REDLINE REVISION NO. 5
MD 175 AT DISNEY ROAD; REVISED POLE LOCATIONS IN THE NW QUADRANT

STATE OF MARYLAND
DEPARTMENT OF TRANSPORTATION
STATE HIGHWAY ADMINISTRATION
OFFICE OF TRAFFIC & SAFETY
TRAFFIC ENGINEERING DESIGN DIVISION
MD 175 (ANNAPOLIS ROAD) AT
26TH STREET/DISNEY ROAD
FORT MEADE, MD

MOT PHASE 3B - TRAFFIC SIGNAL PLAN

SCALE 1" = 20'	ADVERTISED DATE 4/26/1984	CONTRACT NO. AA 797-501-585
DESIGNED BY MICKEY CORNELIUS	COUNTY ANNE ARUNDEL	
DRAWN BY MICKEY CORNELIUS	LOGMILE 02017507.10	
CHECKED BY	TIMS NO.	
F.A.P. NO. SEE TITLE SHEET	TOD NO.	
TS NO. 1959D3B	DRAWING SG - 15.3 OF 26	SHEET NO. 135 OF 195

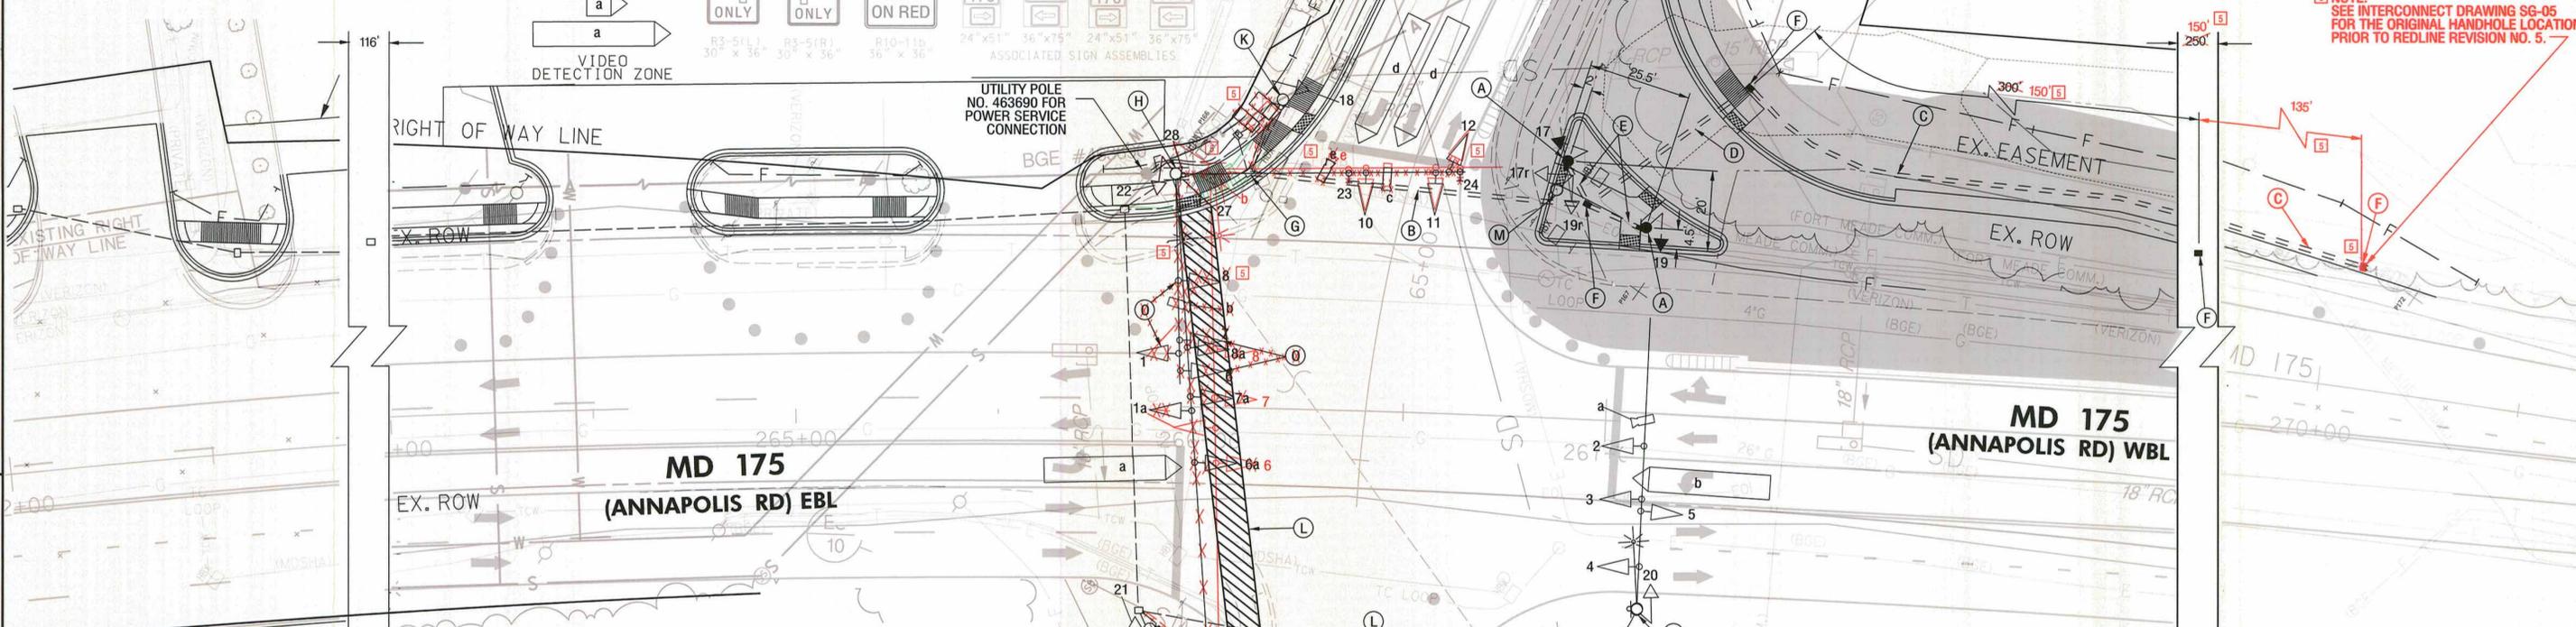
NOTE: SEE INTERCONNECT DRAWING SG-05 FOR THE ORIGINAL HANDHOLE LOCATION PRIOR TO REDLINE REVISION NO. 5.

APPROVALS	REVISIONS
YEAR LEADER	① REDLINE NO. 5 1/27/2013 INSTALL NEW PEDESTAL POLE IN THE NW QUADRANT; RELOCATE SIGNAL POLE ENB
ASST. DIV. CHIEF	② BRAC RECONSTRUCT TRAFFIC SIGNAL SHA # AAS805370 10/2010 TIMS NO. J-969 ENB
DIVISION CHIEF	③ 1/24/97 ASSUILT SHA# BW860802512 RRZ
OFFICE DIRECTOR
